In-Vessel Inspection Before Head Removal: TMI II Phase II (Tooling and Systems Design)

D. W. Greenlee

July 1981

B&W'S RESPONSE TO COMMENTS ON
IN-VESSEL INSPECTION BEFORE HEAD REMOVAL
(PHASE II REPORT)

Figure 4.3 SPECIAL LEADSCREW NUT TOOL

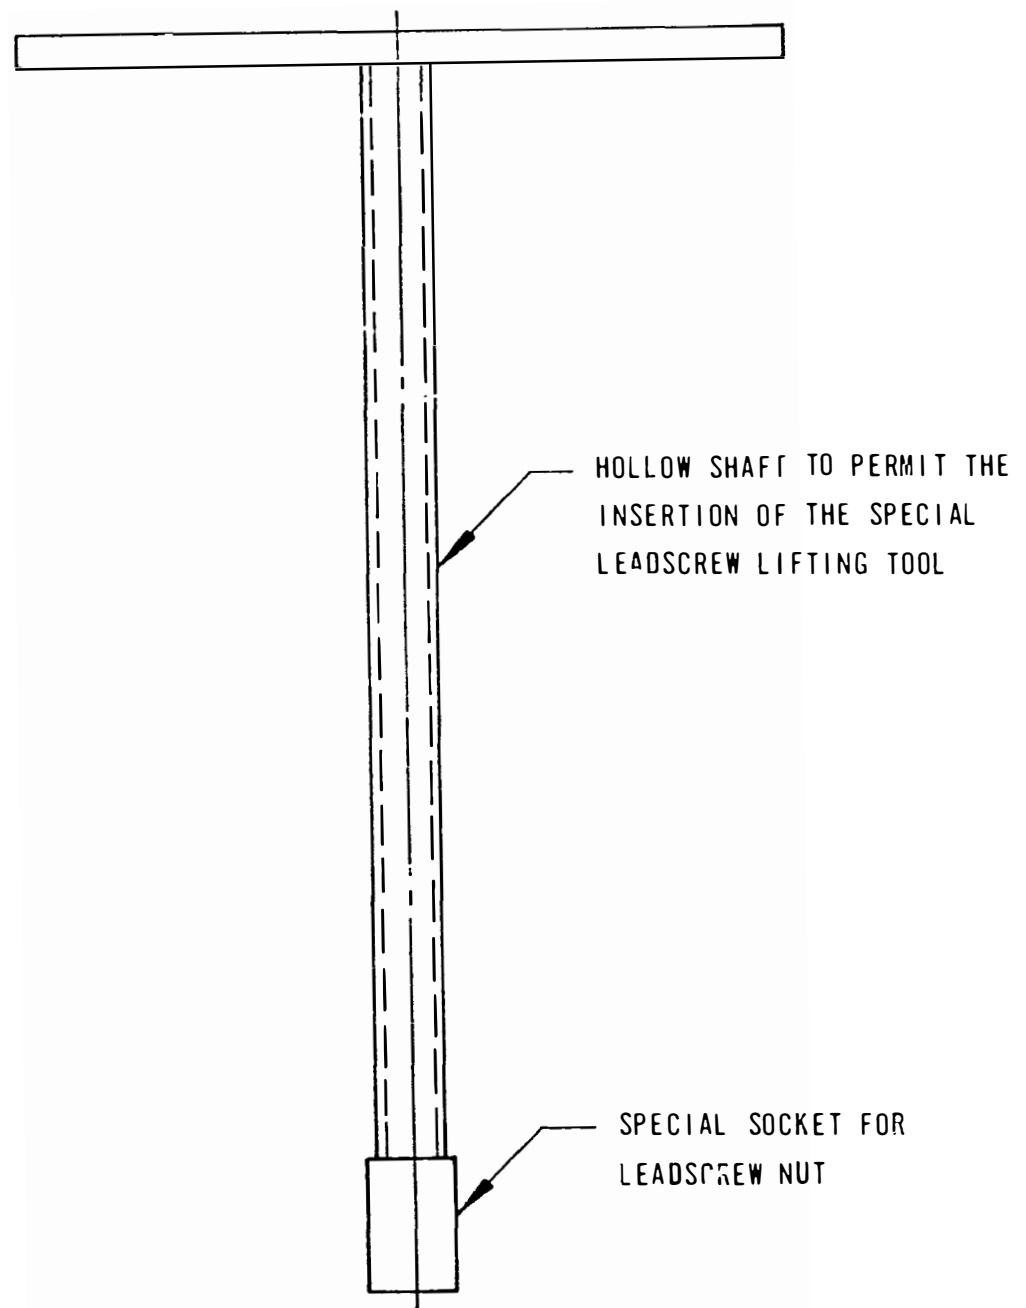
2. The contingency tools that replace the leadscrew installation/removal tools have several disadvantages: 1) the special leadscrew nut tool apparently does not provide a restraint to prevent rotation of the leadscrew into the uncoupled position, and 2) the special leadscrew nut tool apparently does not provide for torque monitoring or control.
